**HISTORIC LANDMARK COMMISSION
STAFF REPORT**

**31 E Hillside Avenue
New Construction-Single Family Dwelling**

**New Construction- PLNHLC2015-00224
Special Exceptions- PLNHLC2015-00281**

Meeting Date: May 14, 2015

A2.50

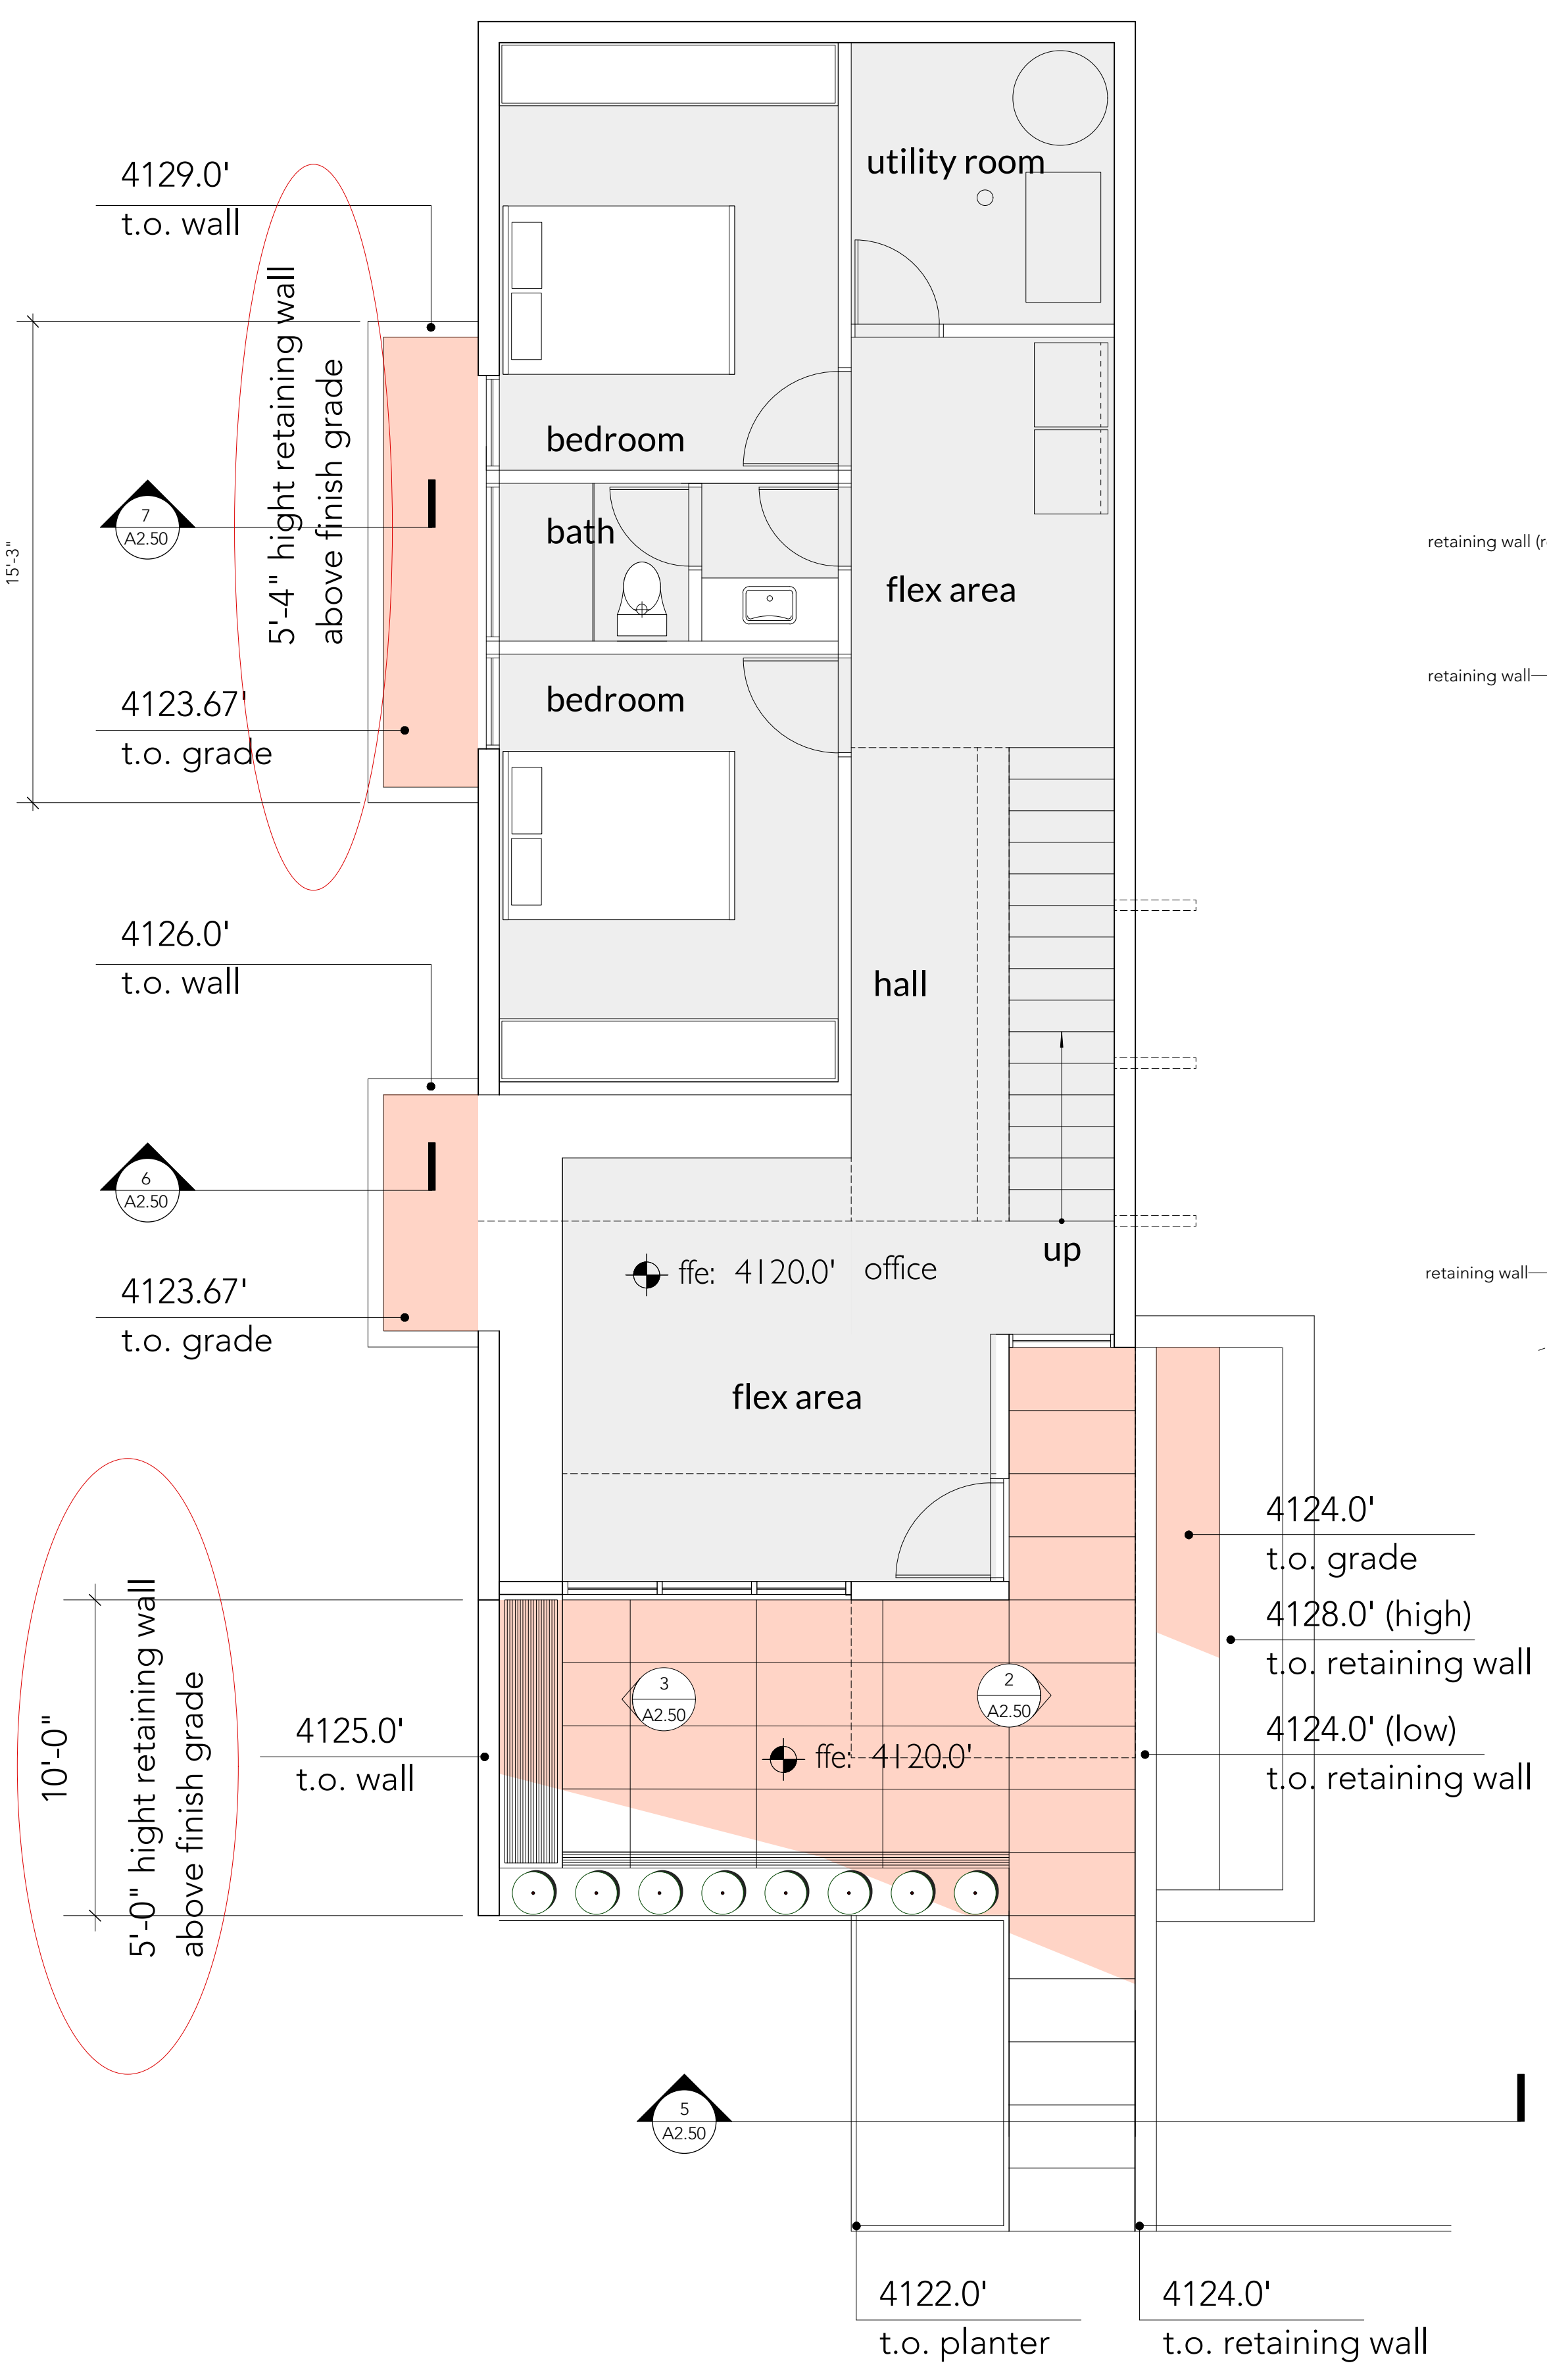
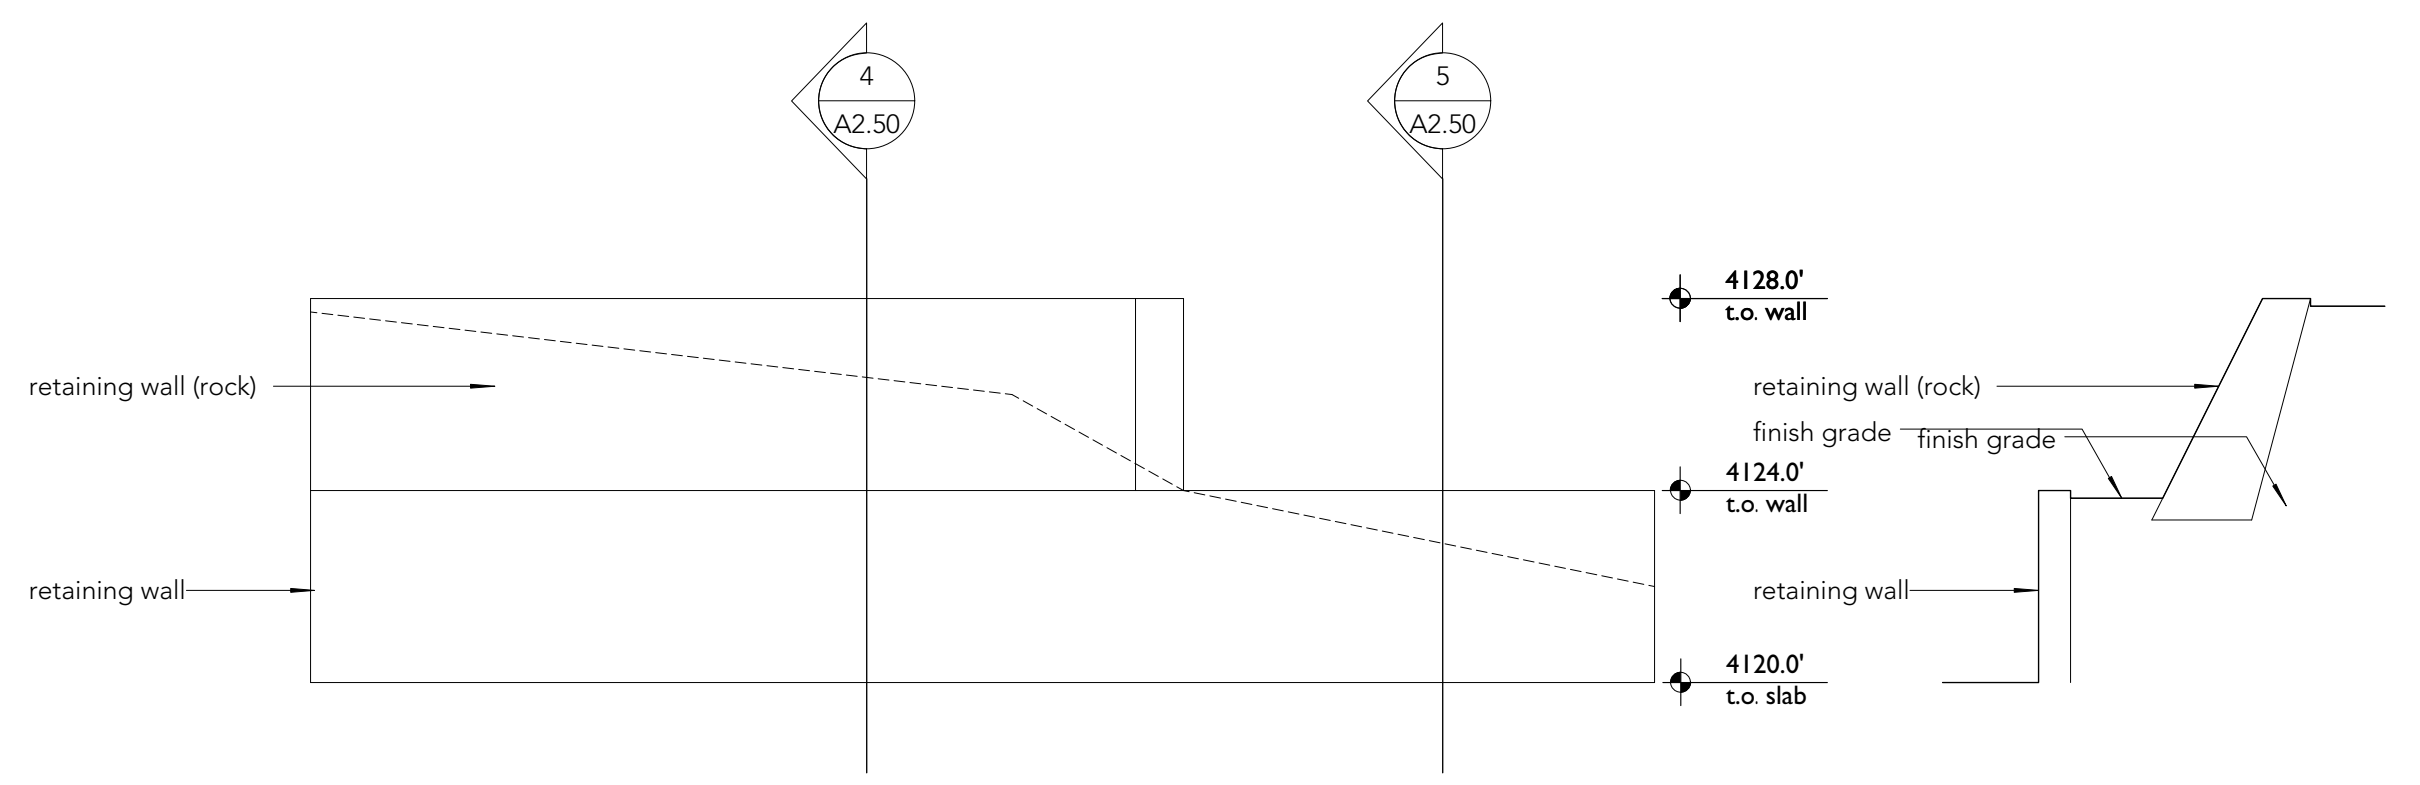
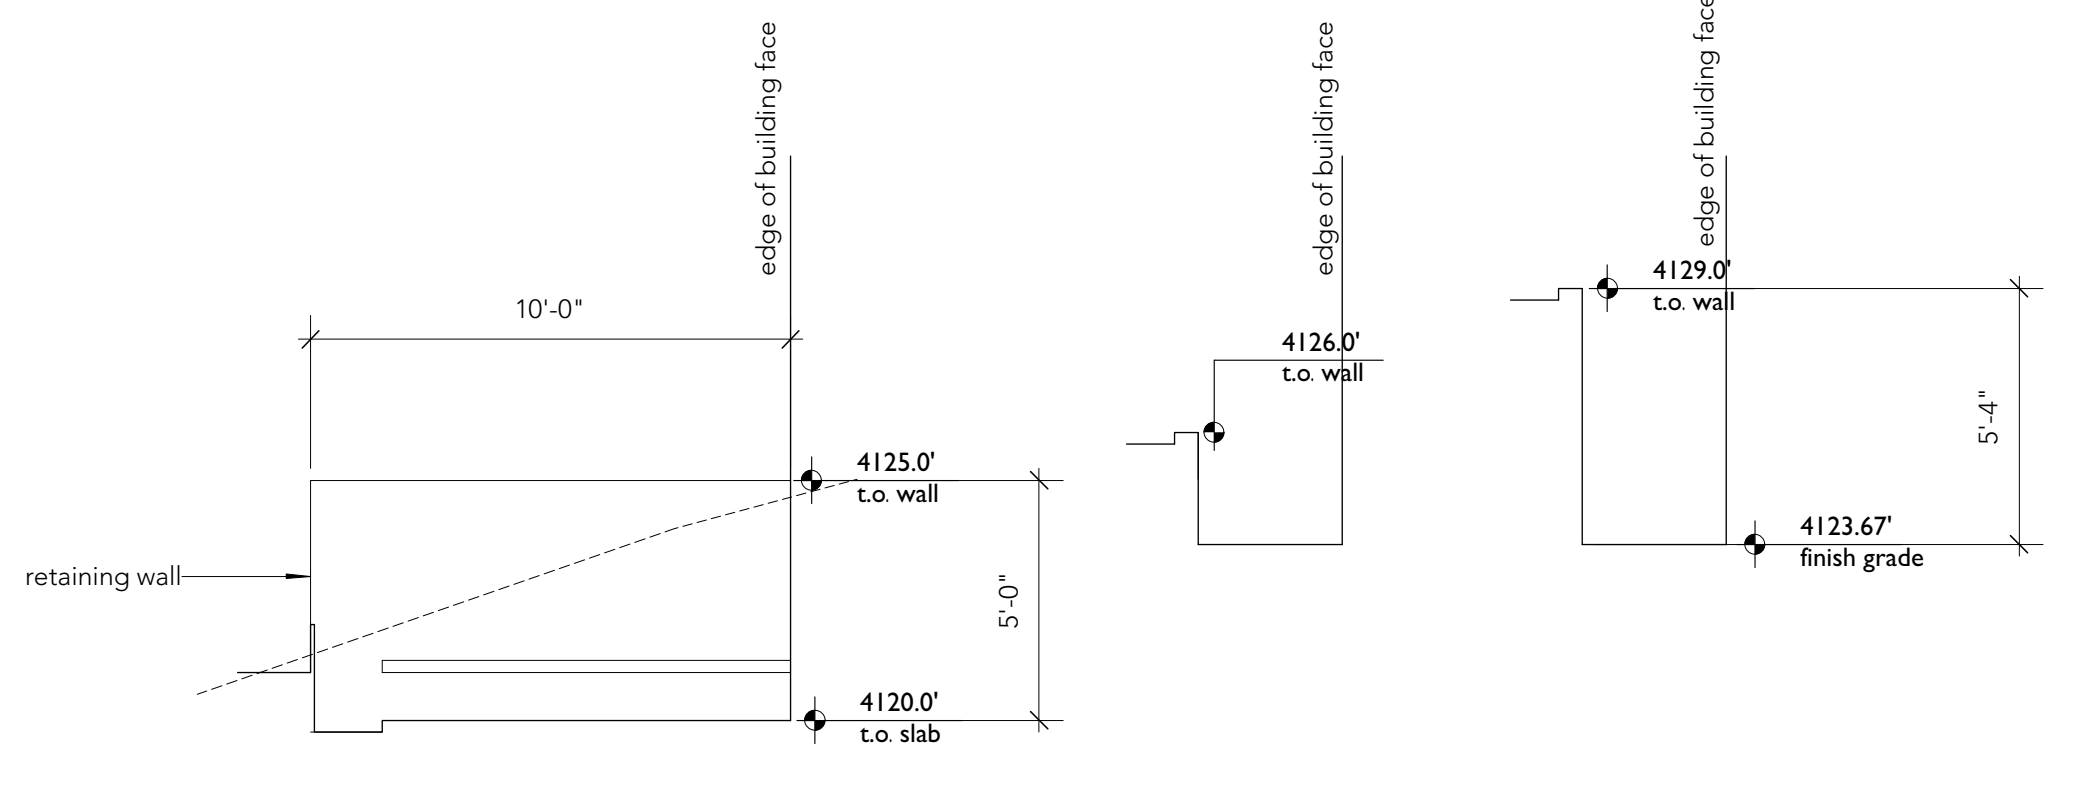
3. **Grade Changes:** In order to accommodate the construction of the proposed single-family home, grade changes in excess of 4 feet (4') are proposed in the corner side yard and the front yard area to accommodate a walk in basement and window wells for the property. The highest point of grade change is approximately 5 feet 5 inches (5'5"). (See Attachment A sheet A2.50)
